Access Compliance Report

Public Rights-of-Way

Intersection ID: 29424	Main Street: BRADSTREET_COMMONS_WY	Cross Street: BRAWLEY_LN	Location: NW
ADA ID: 288EA0704412	Ramp Type: Perp	Initial Pass/Fail: Fail	Overall Compliance: No
Codes/Mitigation Info/Possible Solution		Field Measurements/Component Compliance	
Severity Score: 13.75

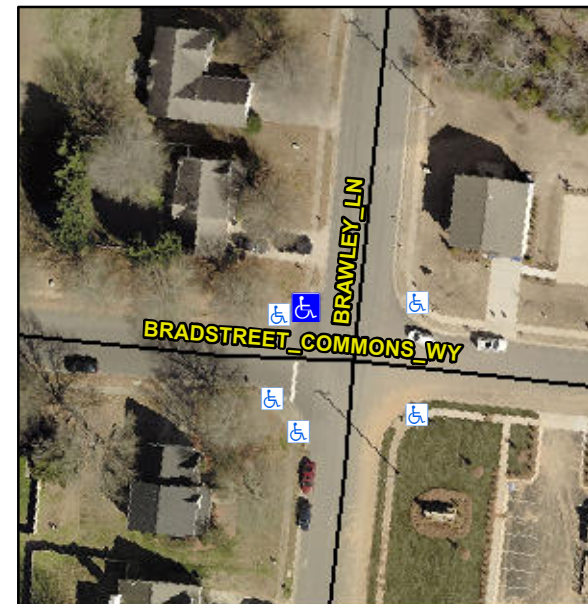
Not Found, R304.2.2, R304.5.3

Compliance	Description	Data	Compliance	Description	Data
N/A	Ramp Length (in)	47.0	No	Ramp Slope (%)	11.9
Yes	Ramp Width (in)	48.0	No	Ramp XSlope (%)	3.8
N/A	Flare Type LT	N/A	N/A	Flare Type RT	N/A
N/A	Flare Slope LT (%)	N/A	N/A	Flare Slope RT (%)	N/A
N/A	Flare Traversable LT?	N/A	N/A	Flare Traversable RT?	N/A
N/A	Landing Length (in)	N/A	N/A	DWS Provided?	N/A
N/A	Landing Width (in)	N/A	N/A	DWS Contrast?	N/A
N/A	Landing Slope (%)	N/A	N/A	DWS Length (in)	N/A
N/A	Landing X Slope (%)	N/A	N/A	DWS Full Width?	N/A
N/A	Landing Curb? (Y/N)	N/A	N/A	DWS Offset (in)	N/A
N/A	Shared Landing?	N/A			
N/A	Gutter Ponding?	N/A	N/A	Gutter Slope (%)	N/A
N/A	Gutter Lip Ht (in)	N/A	N/A	Gutter X Slope (%)	N/A
N/A	Painted X Walk1?	No	N/A	Painted X Walk2?	N/A
	X Walk 1 Direction	To E		X Walk 2 Direction	N/A
N/A	X Walk 1 Width (in)	N/A	N/A	X Walk 2 Width (in)	N/A
	X Walk 1 Slope (%)	4.1		X Walk 2 Slope (%)	N/A
	X Walk 1 X Slope (%)	1.2		X Walk 2 X Slope (%)	N/A

Remove & Replace Entire Ramp.
